PEUGEOT / CITROËN THERMOSTAT REDESIGN TO OVERCOME OVERHEATING

Issue Date: 22/06/18 Issue Number: COTB0021B

APPLICATION: Citroën C3 II, C3 Picasso, Peugeot 2008, 207, 208, 508, Partner Box

APPLICABLE REFERENCES: BBT422 / BBT454

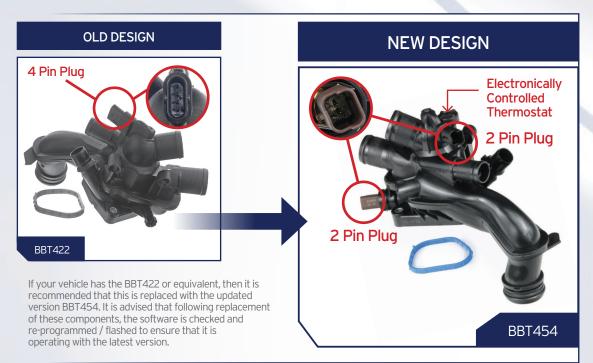
Due to an increase in overheating issues & symptoms such as an erratic temperature gauge, erratic running, radiator fan run-on, or poor heater function in the above vehicles, the O.E.M. have modified the design of the Thermostat housing. Following the O.E. specification, we have replaced the old design BBT422 with the new latest design BBT454. The latest design benefits from an electronically controlled thermostat, a reinforced structure, and a new configuration of sensors.

We have highlighted the key differences below so that you are clear that the latest part, although visually different to what may be on the vehicle, is in fact the correct product.

The modified version has two 2 Pin connectors instead of the one original 4 Pin connector, therefore a new cable is also required to carry out the modification.

New Cable: BTS3091 - Thermostat Wiring Harness
